**Meeting of the Central Valley Flood Protection Board
June 24, 2011**

**Staff Report – Encroachment Permit
Reclamation District No. 17
Landscape Planting, San Joaquin County**

Consider approval of Permit No. 18518-A (Attachment B)

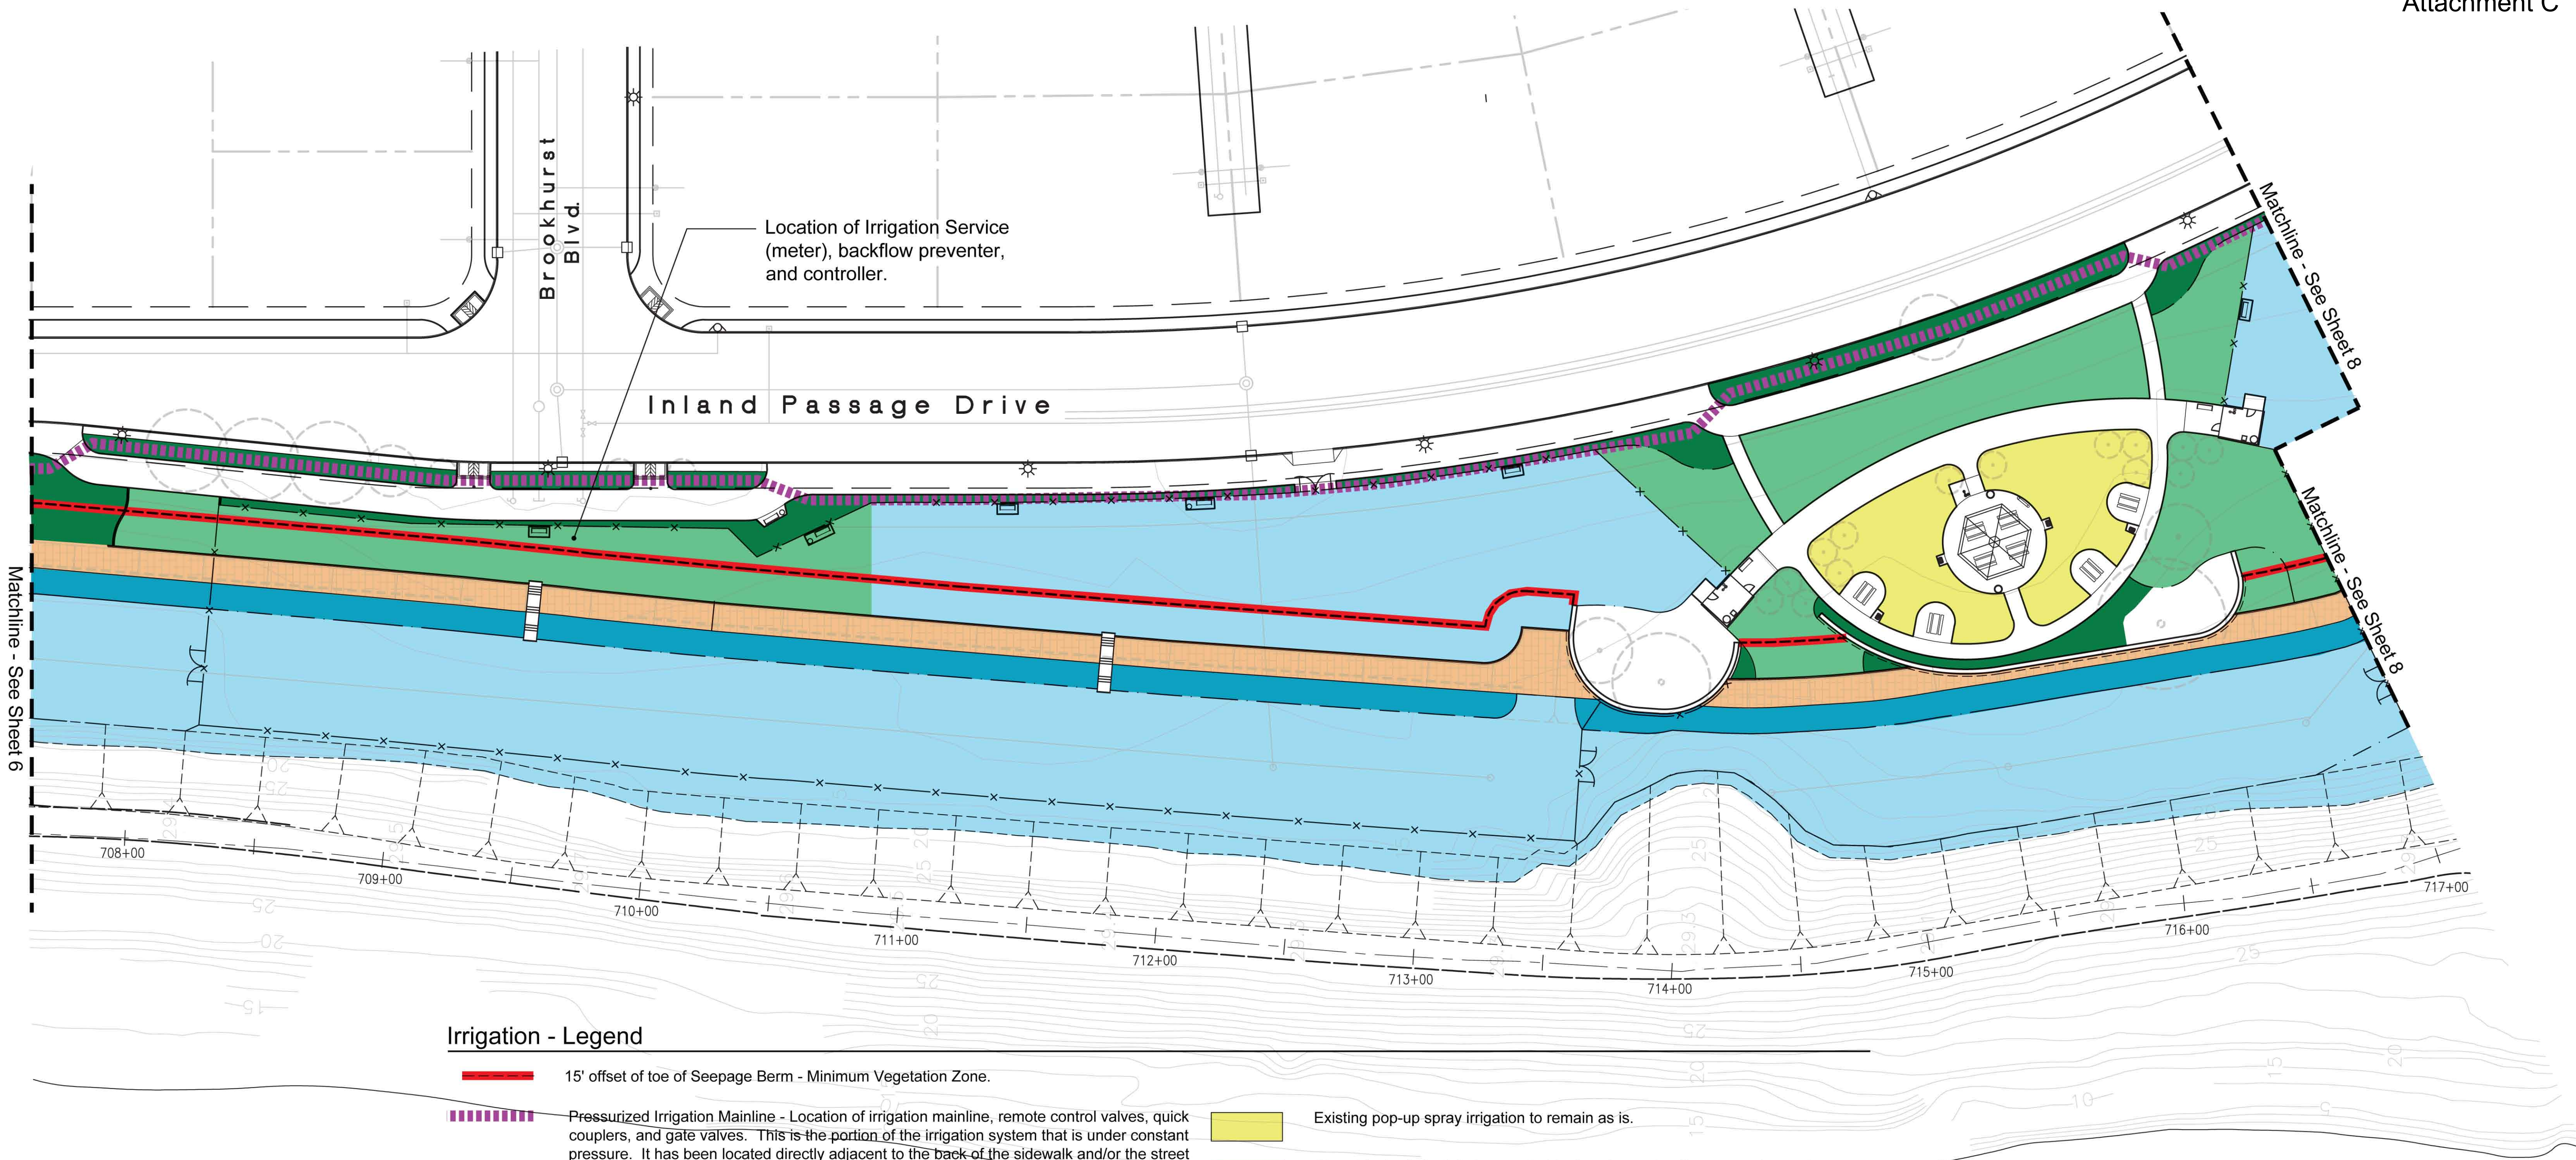
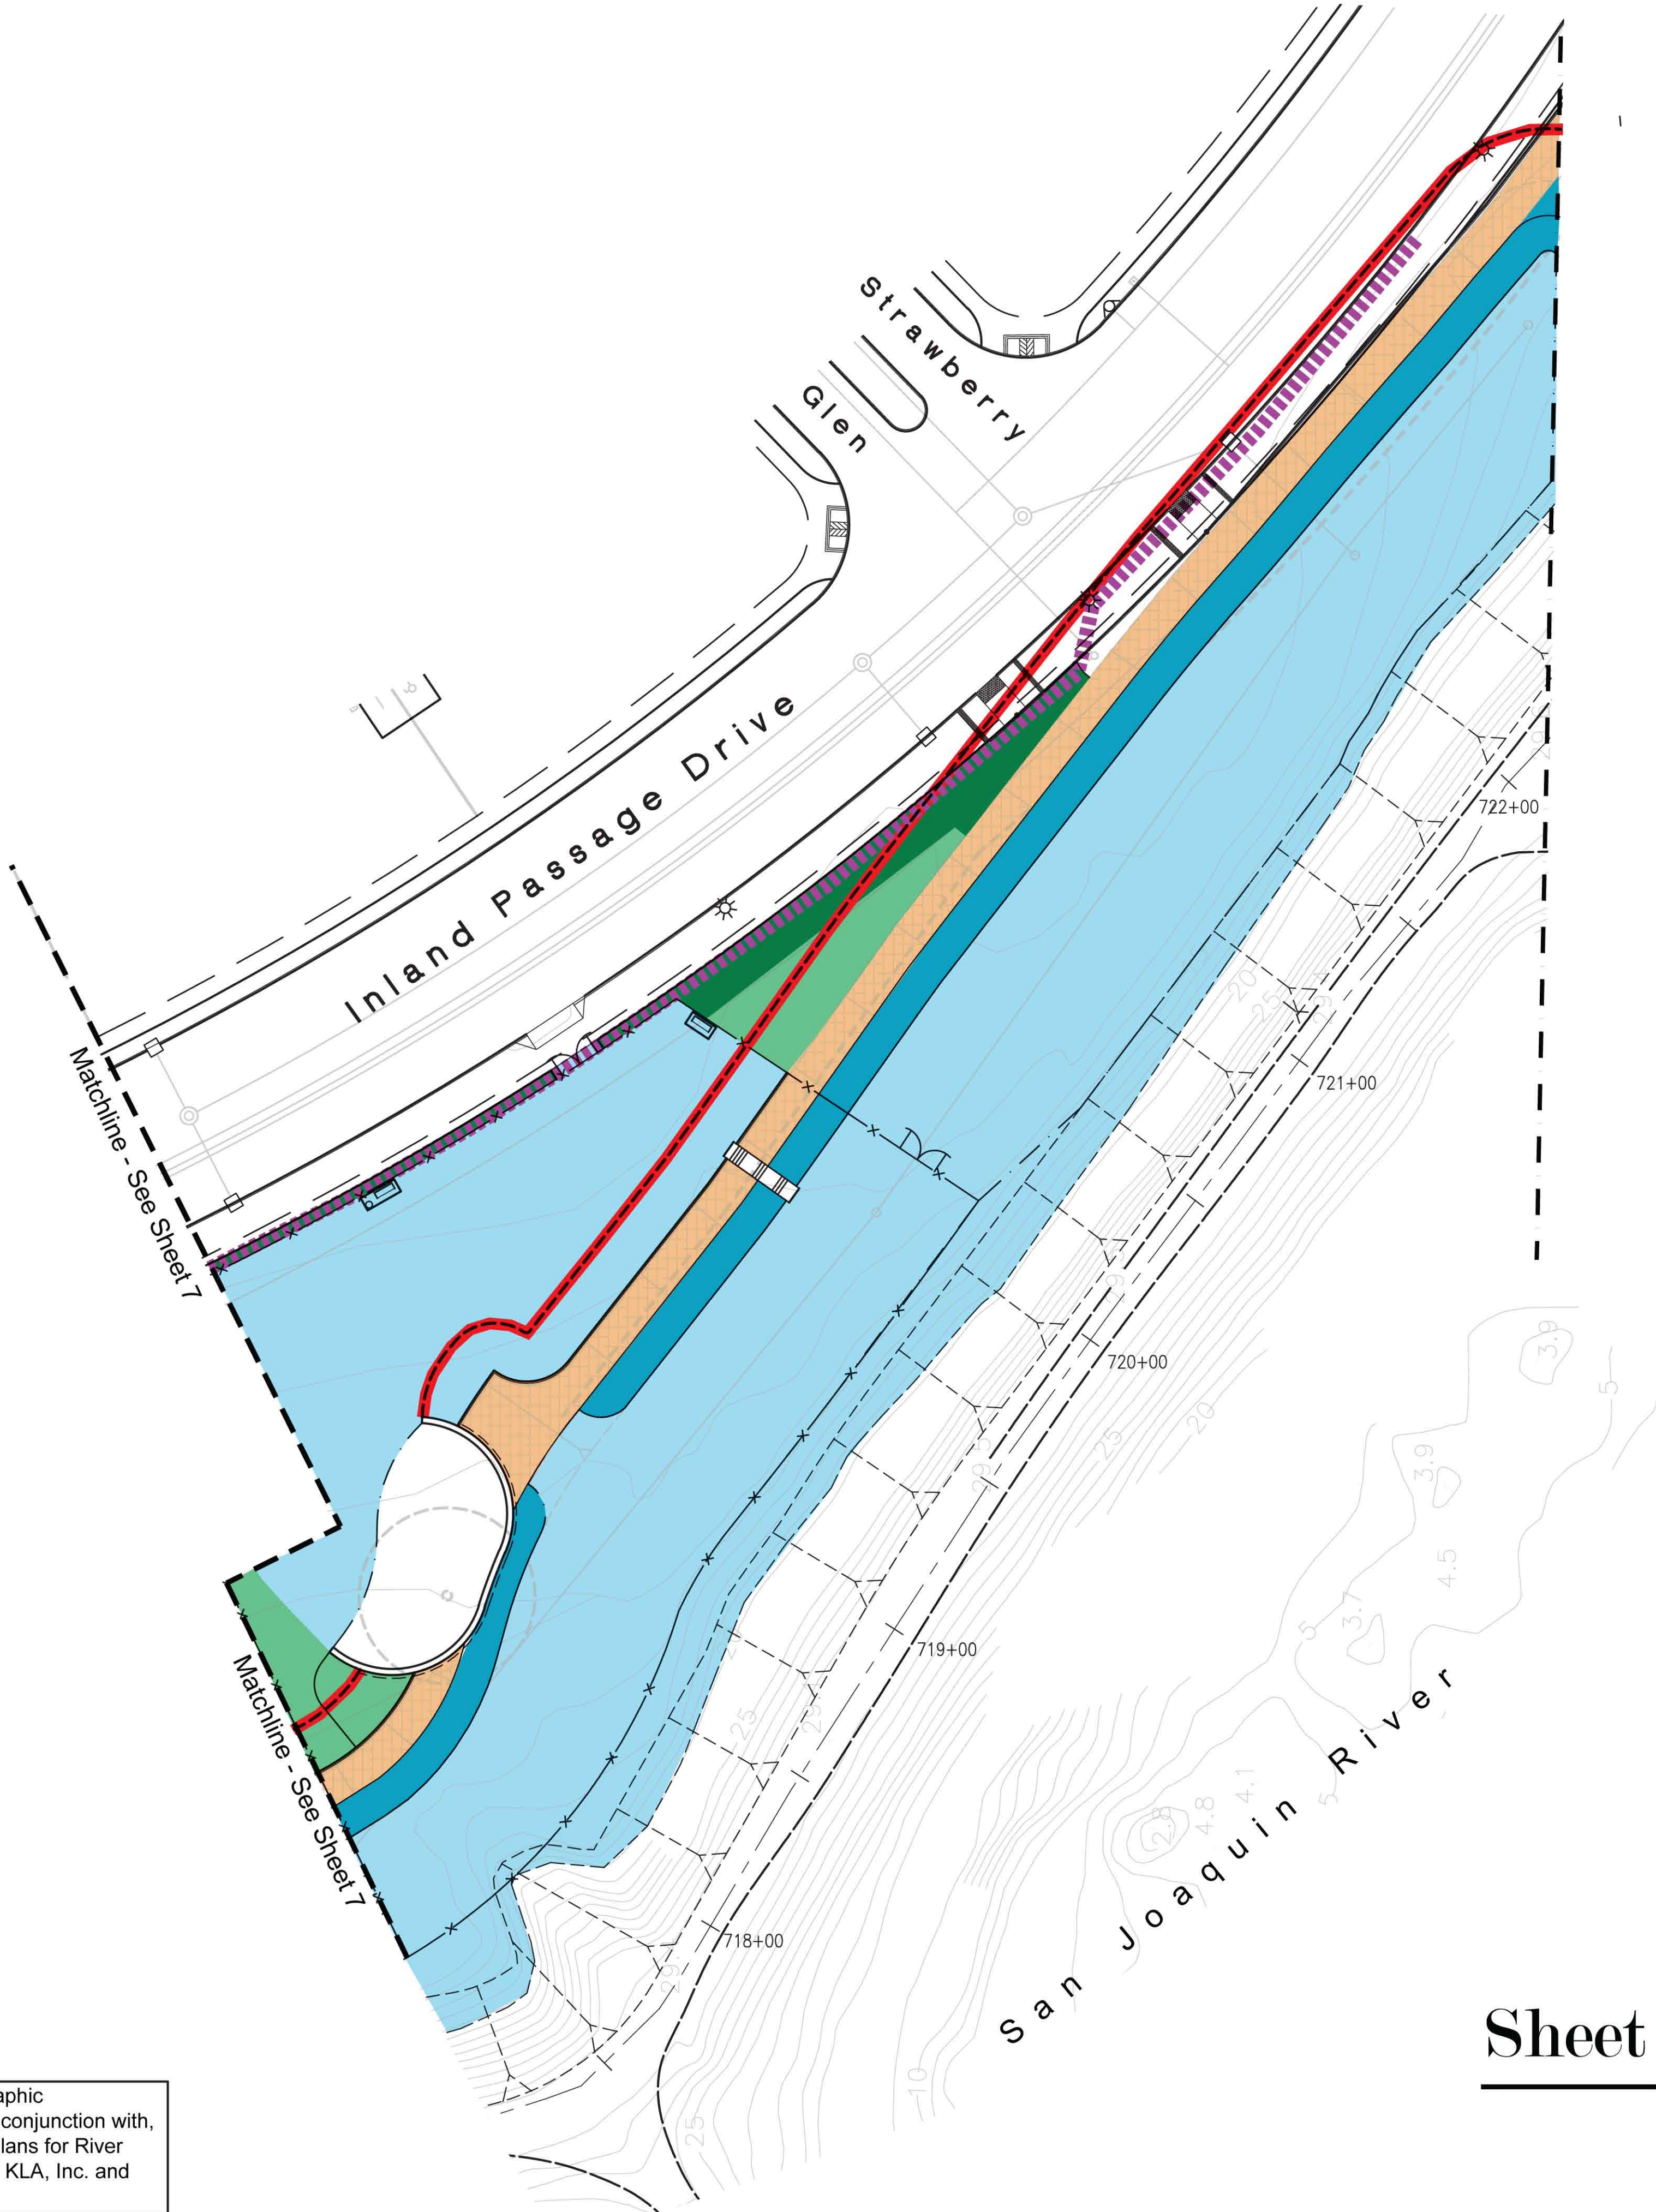
The only technical concern of the aforementioned encroachments is the irrigation improvements. The concern is that during the non-flood season the irrigation improvements introduce a new water source at this site (artificial rain) in an unknown quantity. The permit will include language that requires the permittee to monitor the existing underseepage collection system during operation of the irrigation improvements by submitting to a plan for monitoring that is acceptable to the Board with consideration for any mitigation needed to assure the system operates as designed at all times.

THIRTY-SEVEN: The permittee shall submit a plan for monitoring the existing underseepage collection system during operation of the irrigation improvements that is acceptable to the Central Valley Flood Protection Board with consideration for any mitigation needed to assure the system operates as designed at all times. This plan is to assess the first season of use after installation or longer if needed.
